Replacement Parts Bulletin

For Line Backer™ Circuit Switchers

Figure 2 – Pre-November 1983 Shunt Trip Design

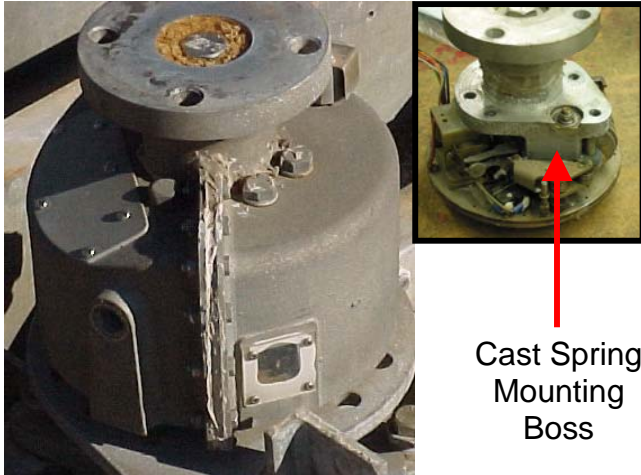
- Over time the seals for the two-piece casting (Figure 2) allowed moisture to enter the shunt trip resulting in component corrosion and electrical shorts. This led to nuisance operations or the disabling of the desired high speed tripping capability of the interrupter.
- The pre-November 1983 shunt trip design utilized a cast spring mounting boss (Figure 2). Multiple operations and corrosion caused by exposure to moisture can cause a fatigue crack in the boss that propagates throughout the casting, disabling the shunt trip.

- Replace your existing shunt trip with the current design (see Figure 3) that is a bolt-for-bolt replacement.

Figure 6 – “Dog leg” style hinge

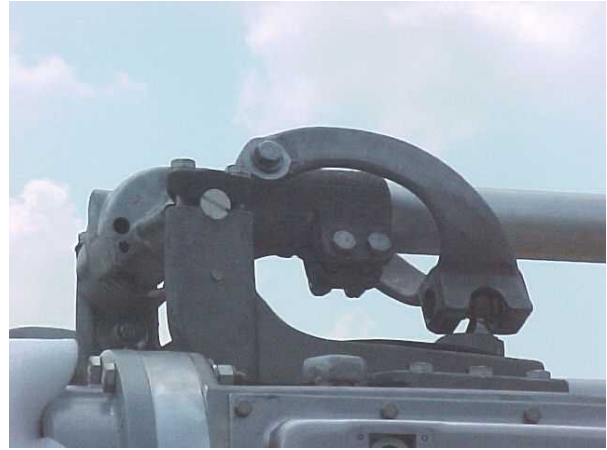
- A geometric dead spot exists in the “dog leg” style hinge (see Figure 6). If the blade stops in the dead spot or seizes in any position, one or more hinge components may fail. The potential for failure is magnified because the aluminum pivot is vulnerable to oxidation which causes the hinge to seize, resulting in a component failure.

Upgrade to a TA-OC style hinge that has 30+ years of demonstrated reliable performance in the field. Since 1999, the TA-OC style hinge’s cross sectional area has been increased for improved performance under iced conditions. Due to the differences in hinge configuration an upgrade must also include a new blade, as the “dog leg” style hinge’s blade is too short to work with the TA-OC style hinge.

Figure 8 – Shows the output shaft and the nylon auxiliary switch drive chain for the auxiliary contacts

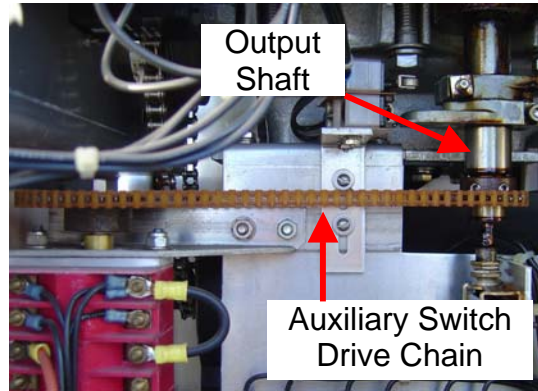
- If you have a three-door CM-4, CM-4A, or CM-4AL motor operator then under normal operating conditions grease can seep down the output shaft and into the reversing contactor, potentially causing an uncommanded operation of the circuit switcher. Two-door motor operators do not have this problem because their reversing contactor is located in a different location.
- The nylon auxiliary chain furnished in older CM-4, CM-4A, and CM-4AL motor operators will degrade and break, preventing the auxiliary contacts from changing state and making it impossible to determine, from a remote location, if the circuit switcher is closed or open.

- Check to see if you have a nylon auxiliary switch drive chain. If so, inspect your auxiliary switch drive chain to determine if it is brittle or has any “stripped” bushings.
- Next inspect for the presence of liquefied grease on the motor operator drive shaft.

- If you have a nylon drive chain an immediate replacement with our stainless steel drive chain is strongly recommended regardless of condition.
- Replacement of your motor operator with the CM-4AE motor operator is recommended if you are experiencing grease leakage.
